EARLY DESIGN GUIDANCE 2

**9218 18th Ave SW
Seattle, WA 98106**

3036383-LU
3036384-LU
3036524-EG

ITEMIZED RESPONSE TO EDG 1

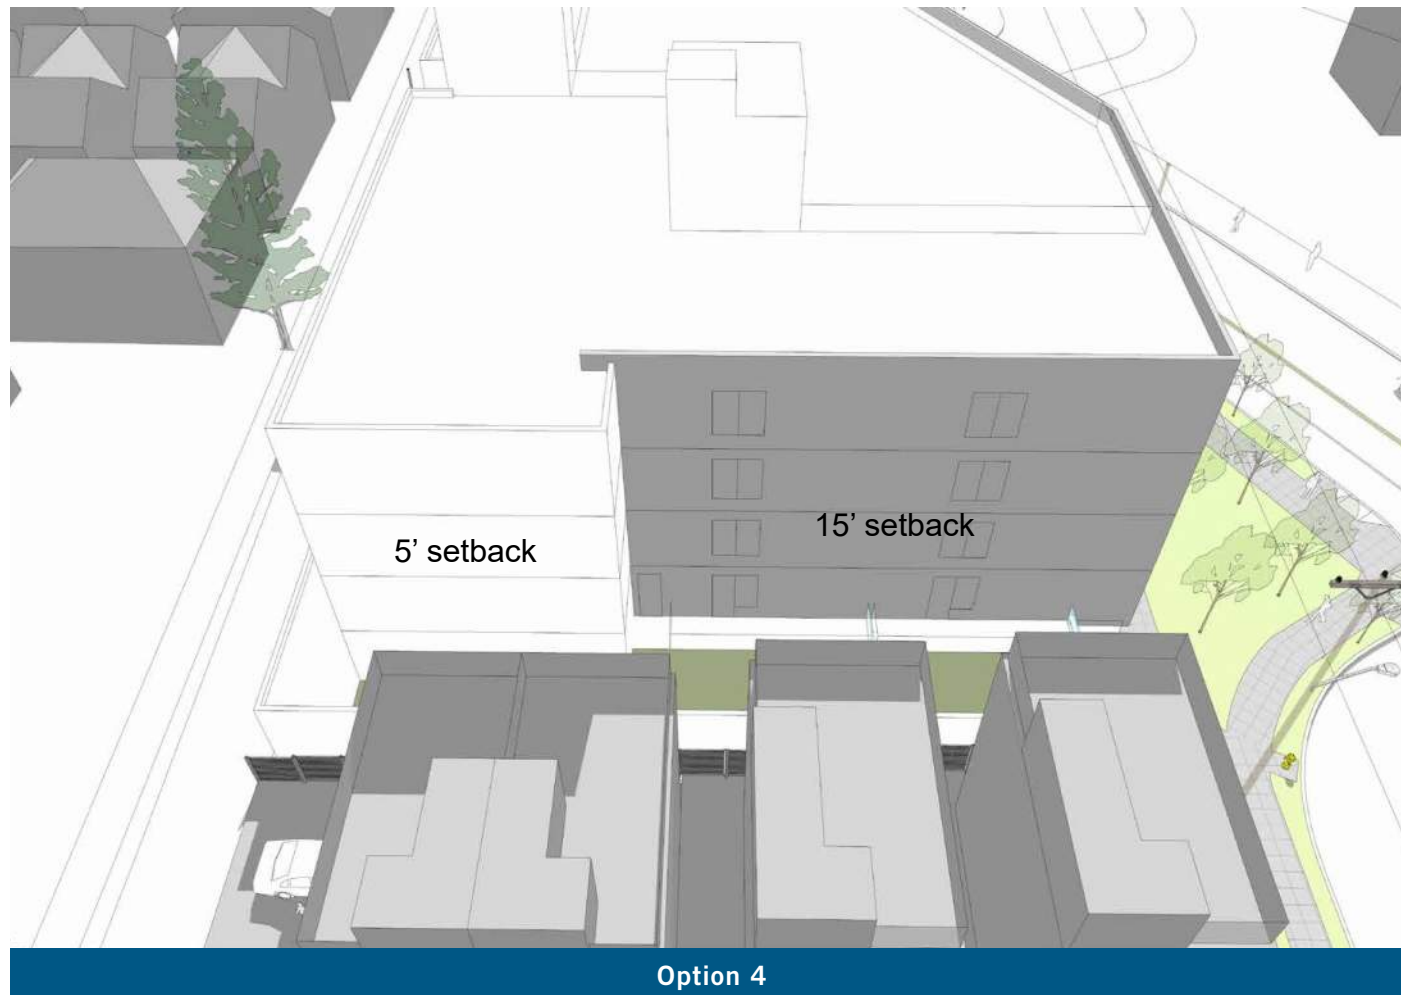
1.c. The Board discussed the proposal's attempts to relate to the townhomes north of the site and observed that this design direction seemed to be the source of some of the less harmonious aspects of the design. The Board recommended instead that the applicant plan for and embrace the future context of Delridge Way SW, which is likely to consist of many large-scale multi-family buildings and a more urban context. (CS3-A-4)

RESPONSE: Although the site to the south is unlikely to be fully developed, due to its irregular triangle shape, this option does account for the potential of a building being developed. The continuous facade along 18th Ave SW and Delridge Way SW creates a balanced and strong 'Urban Edge' that reflects the grid shift and the future context of the site.

RESPONSE: Although the site to the south is unlikely to be fully developed, due to its irregular triangle shape, this option does account for the potential of a building being developed. The mass that fronts Delridge provides a strong 'Urban Edge' that reflects the future context of the site, while the setback mass on 18th Ave creates a hierarchy in the massing that reflects the residential street.

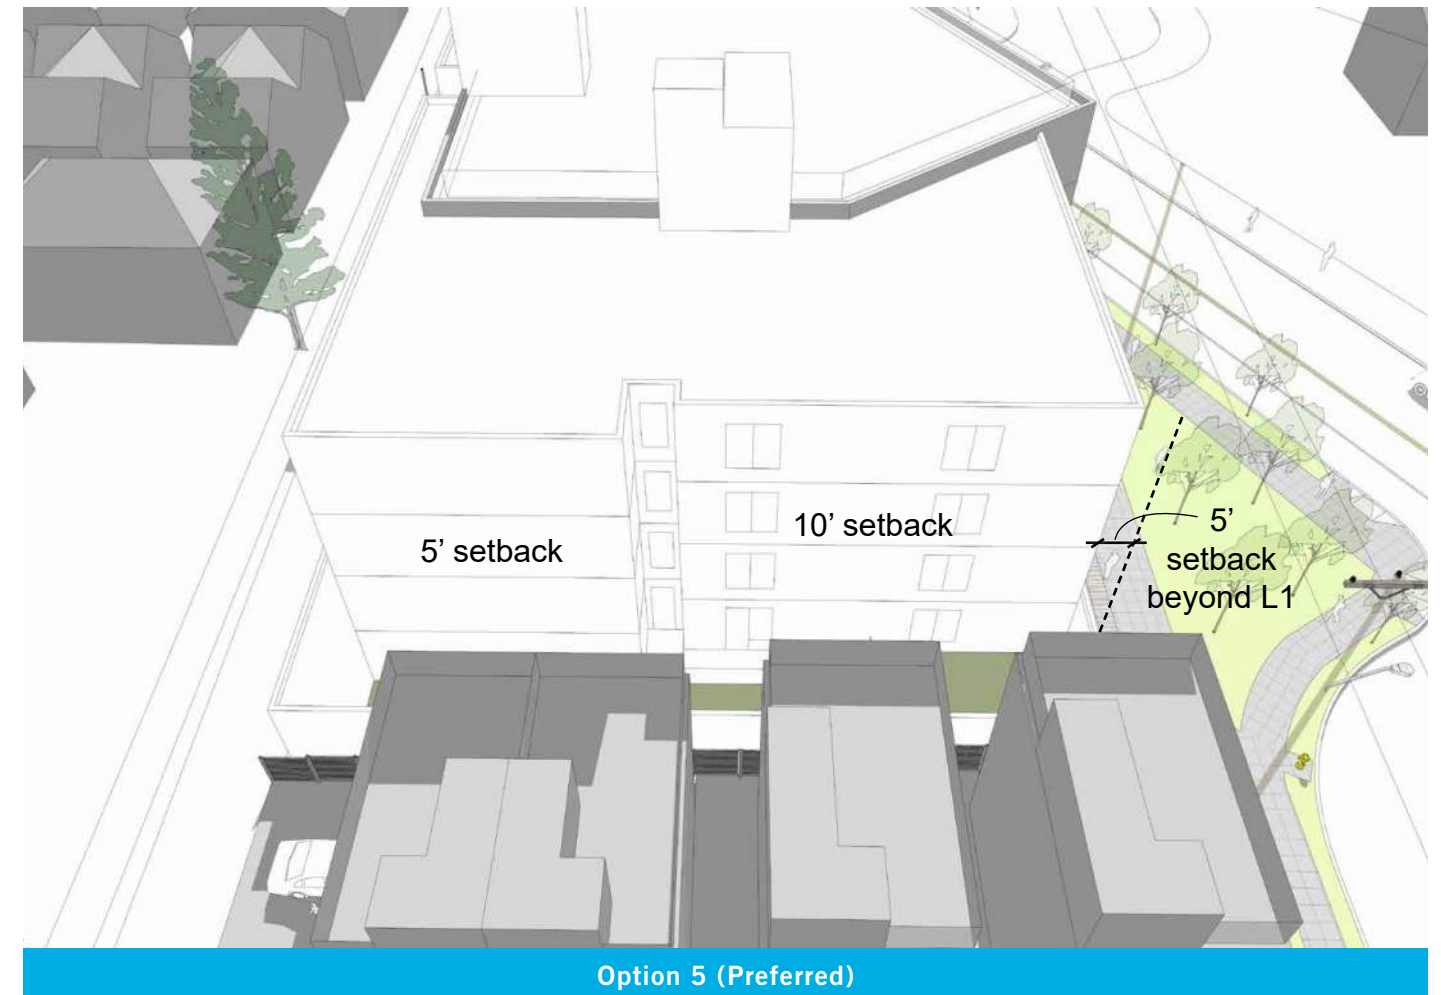
1.d. The Board was particularly concerned about the large expanses of blank wall proposed on the north and south facades. The Board directed the applicant to integrate glazing into these facades to reduce the impacts associated with the blank walls and to improve solar access for residents. At the next EDG meeting, show fenestration for each proposed massing model. (CS1-B-2, DC2-B-2)

RESPONSE: This option divides the north facade into two masses that prevents an expanse of blank wall. The 15' setback from the north property line allows the integration of fenestration on the facade. Carefully located windows reduce the chance for privacy concerns for both the building tenants and the adjacent townhouses.

RESPONSE: This option divides the north facade into two masses that prevents an expanse of blank wall. The 10' setback from the north property line allows the integration of fenestration on the facade. A recess at the intersection of the corridor and north facade allows for additional fenestration. The addition of a 5' setback, above L1, on the western facade allows for additional natural light and air to reach the townhouse. Carefully located windows reduce the chance for privacy concerns for both the building tenants and the adjacent townhouses.

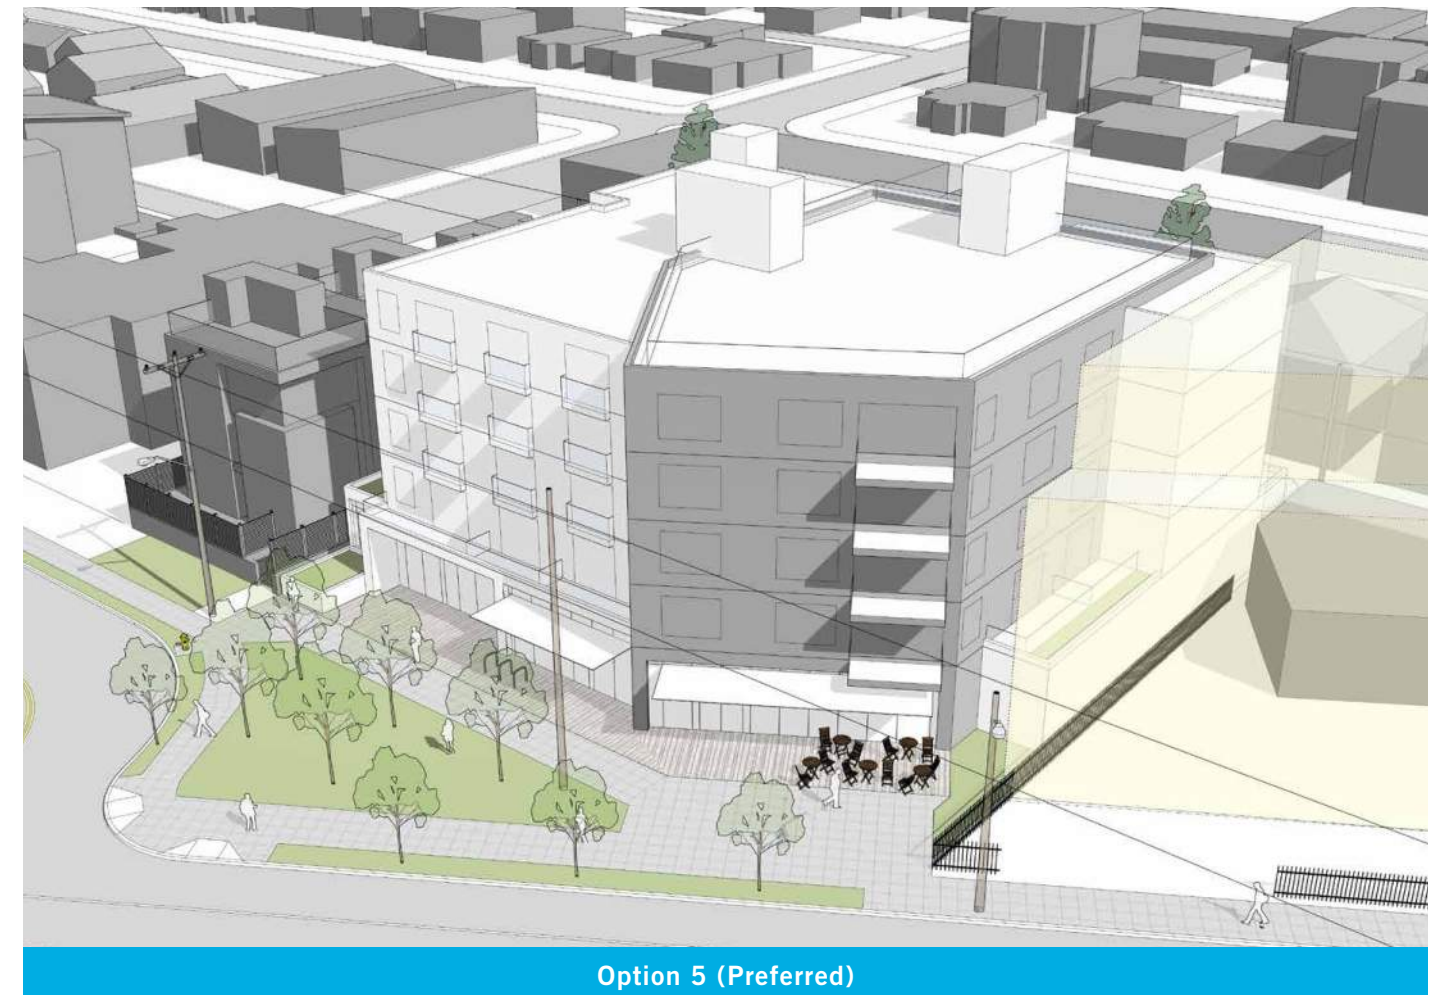
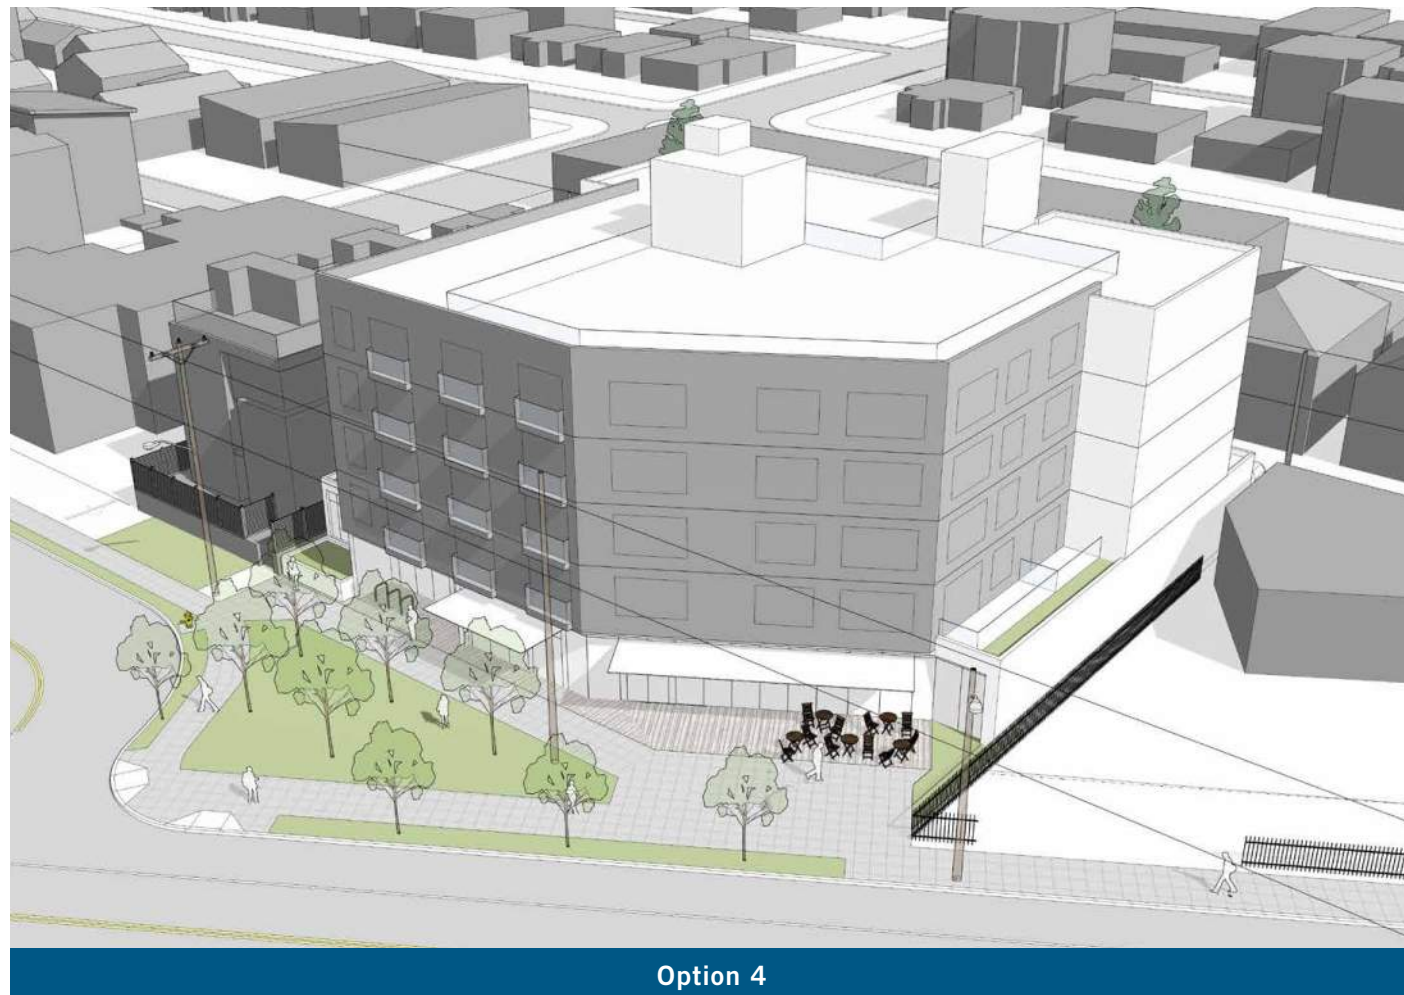
1.e. The Board noted the relatively large size of the proposed commercial space and anticipated that market conditions may necessitate dividing the commercial space into smaller spaces. The Board asked the applicant to be mindful of this possibility as the design is developed to ensure a flexible ground floor that can evolve over time while retaining a strong connection to the public realm. (DC2-E)

1.f. The Board raised concerns about pedestrian connectivity and the streetscape experience. The Board recommended creating opportunities for activity to spill out into the public right-of-way to create a more active and engaging public realm. (PL1-B-3, PL3-C)

RESPONSE: This option uses a continuous facade along the ground floor to allow for maximum flexibility of the commercial space. The internal layout of the commercial space allows for easy demising for future tenants. Although the fence to the south encroaches into the R.O.W., the acute awkward angle is eliminated by setting a portion of the ground floor facade perpendicular to the side lot line. The use of a setback on the ground floor allows for retail activities to spill out and the addition of vegetation creates a secondary layer to the space.

RESPONSE: Although this option divides the facade along the ground floor into two portions, the internal layout allows for easy demising for future tenants. Although the fence to the south encroaches into the R.O.W., the acute awkward angle is eliminated by setting a portion of the ground floor facade perpendicular to the side lot line. The use of a setback on the ground floor allows for retail activities to spill out and the addition of vegetation creates a secondary layer to the space.

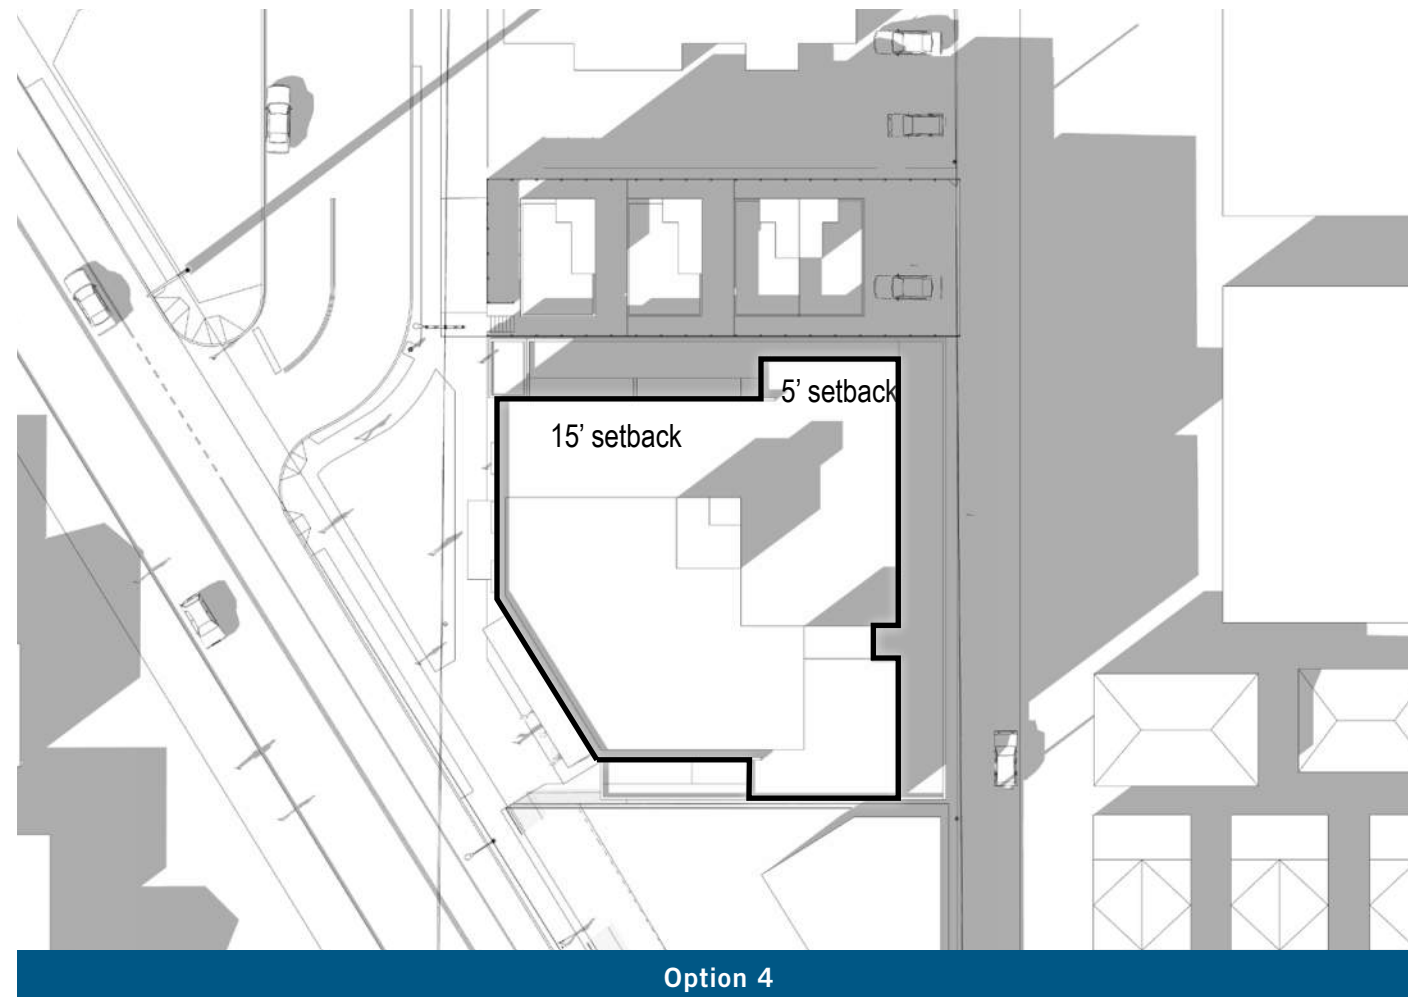
2.a. The Board noted that the blank wall condition of the south façade results in reduced solar access for the residential units. As the design is further developed, keep internal solar access in mind and allow this consideration to inform the overall design concept and internal layout. (CS1-B-2, DC2-B-2)

RESPONSE: This option strikes a balance between maximizing natural light and air to penetrate all units, while acknowledging the townhouses to the north and the potential southern site development. This is accomplished by having the majority of unit fenestrations face the site street and alley. Along the north and south facades, setback are utilized to allow for fenestration while providing mutual relief for the building and adjacent sites. Overall, there are only two units per floor that have their fenestration on the north or south facade.

RESPONSE: This option strikes a balance between maximizing natural light and air to penetrate all units, while acknowledging the townhouses to the north and the potential southern site development. This is accomplished by having the majority of unit fenestrations face the site street and alley. Along the north and south facades, setback are utilized to allow for fenestration while providing mutual relief for the building and adjacent sites. Overall, there are only two units per floor that have their fenestration on the north or south facade.

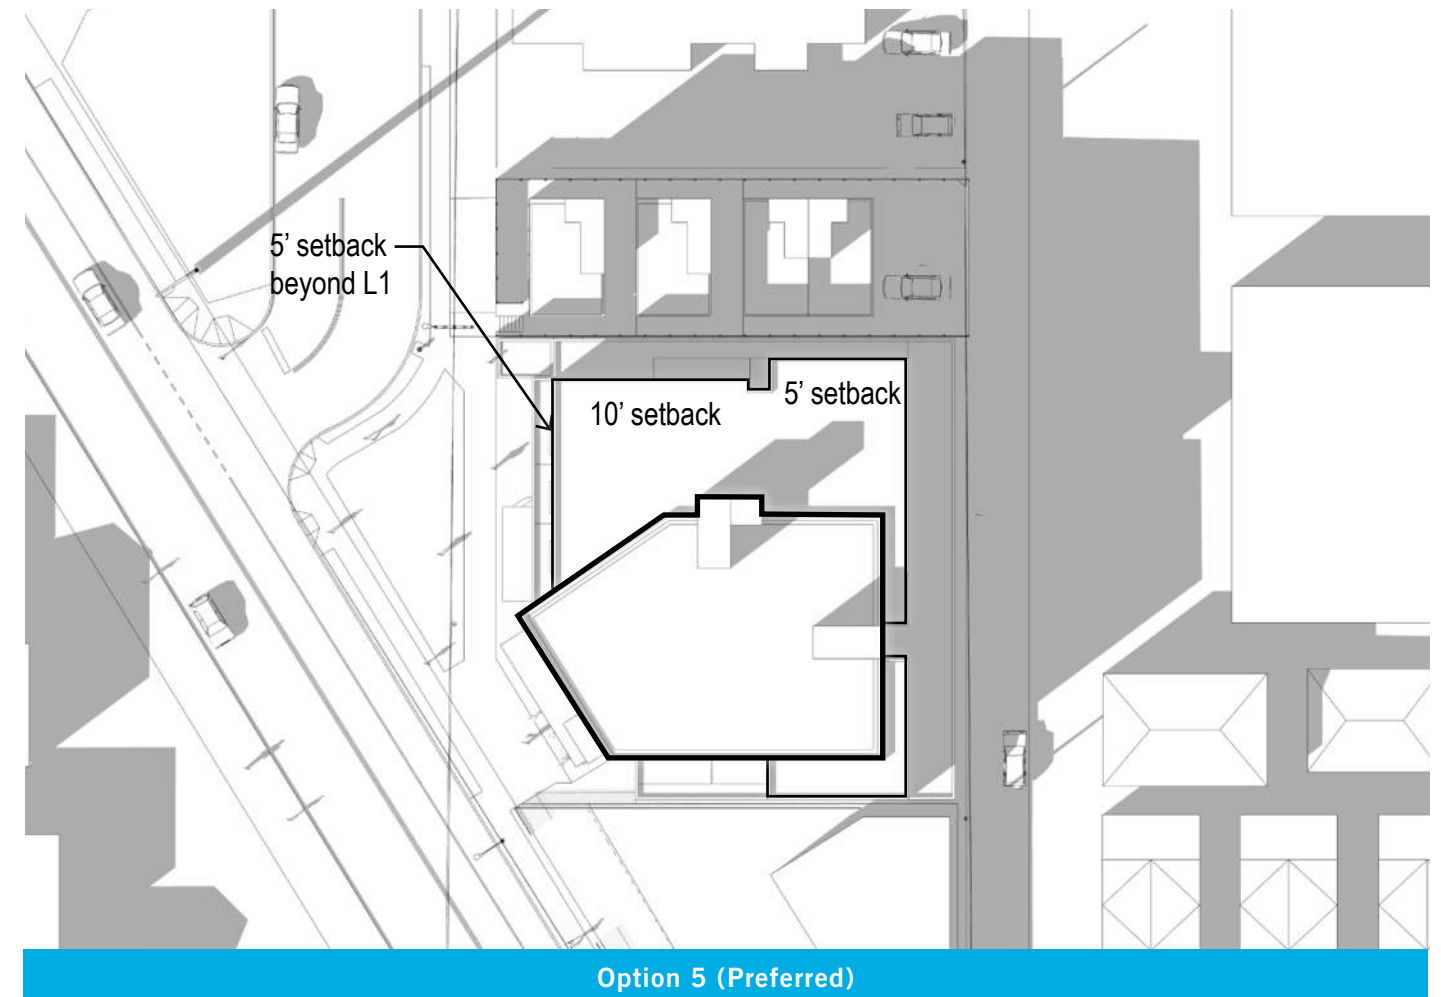
2.b. The Board recommended setting back the upper levels to improve solar access for neighboring properties. (CS1-B-2)

RESPONSE: When compared to Option 5, the proposed additional 5' setback on the NW upper facade of the building, doesn't noticeably reduce the shadows cast onto the existing townhouses. Additionally, the SW upper portion of the building is setback 11' to allow for natural light and air penetration even with the potential of the southern site development.

RESPONSE: The proposed 10' setback on the NW upper facade of the building gives relief to the adjacent townhouses. A 5' setback on the west facade creates additional space for natural light and air penetration. When compared to Option 4, the shadows cast are similar. Additionally, the SW upper portion of the building is setback 11'-6" to allow for natural light and air penetration even with the potential of the southern site development.
